Special Coverage Adjustment

N192268380 Driver Seat Belt Anchor Pretensioner Cable

Release Date: August 2020

Revision: 00

Revised Cover Retainer

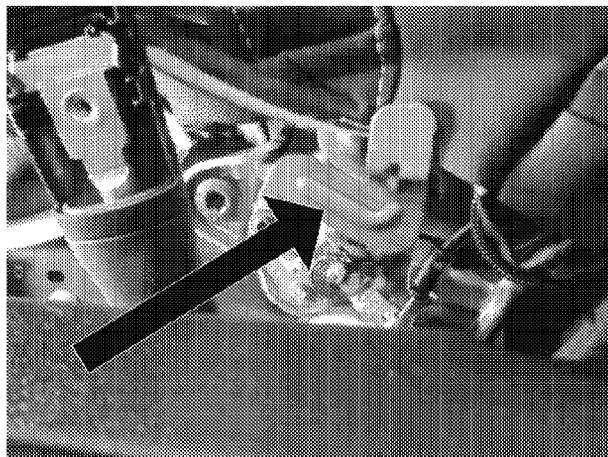
NOTE: When replacing the front seat cushion outer finish cover, it is also necessary to replace the metal cover retainer and pivot bolt mounted bracket.

5. Replace the driver side front seat belt anchor plate pretensioner and the front seat cushion outer finish cover. Refer to *Front Seat Adjuster Finish Cover Replacement* and *Front Seat Belt Anchor Plate Tensioner Replacement* in SI.

Revised Cover Retainer

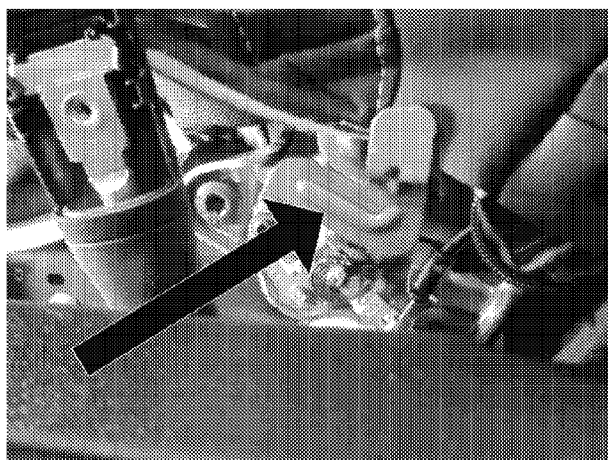
NOTE: When replacing the front seat cushion outer finish cover, it is also necessary to replace the metal cover retainer and pivot bolt mounted bracket.

5. Replace the driver side front seat belt anchor plate pretensioner and the front seat cushion outer finish cover. Refer to *Front Seat Adjuster Finish Cover Replacement* and *Front Seat Belt Anchor Plate Tensioner Replacement* in SI.

18128 Driver's Front Seat Belt Anchor Pretensioner

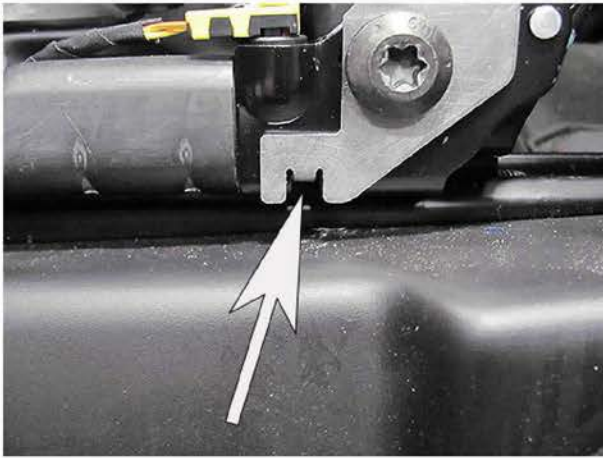
This damage will be in the form of holes (1) or splitting (2).

- If **any damage** is found, replace the driver side front seat belt anchor plate tensioner and the front seat cushion outer finish cover.
- If no damage is found, inform the customer that the special coverage condition is not present on their vehicle at this time.

1. Replace the driver side front seat belt anchor plate tensioner. Refer to *Front Seat Belt Anchor Plate Tensioner Replacement* in SI.
2. Replace the driver side front seat cushion outer finish cover. Refer to *Front Seat Cushion Outer Finish Cover Replacement* in SI.

18127 Driver's Front Seat Belt Anchor Pretensioner

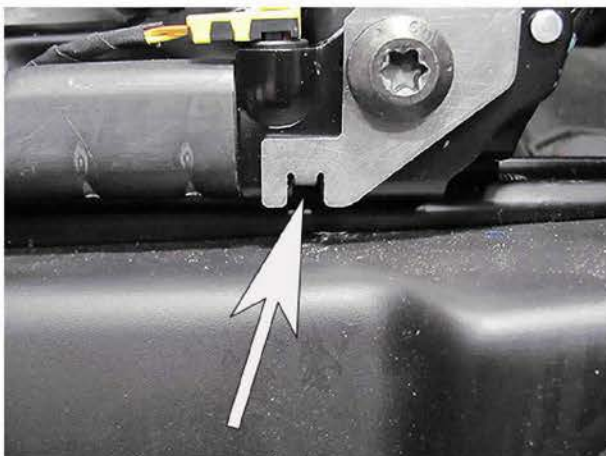
This damage will be in the form of holes (1) or splitting (2).

- If **any damage** is found, replace the driver side front seat belt anchor plate tensioner and the front seat cushion outer finish cover.
- If no damage is found, inform the customer that the special coverage condition is not present on their vehicle at this time.

1. Replace the driver side front seat belt anchor plate tensioner. Refer to *Front Seat Belt Anchor Plate Tensioner Replacement* in SI.
2. Replace the driver side front seat cushion outer finish cover. Refer to *Front Seat Cushion Outer Finish Cover Replacement* in SI.
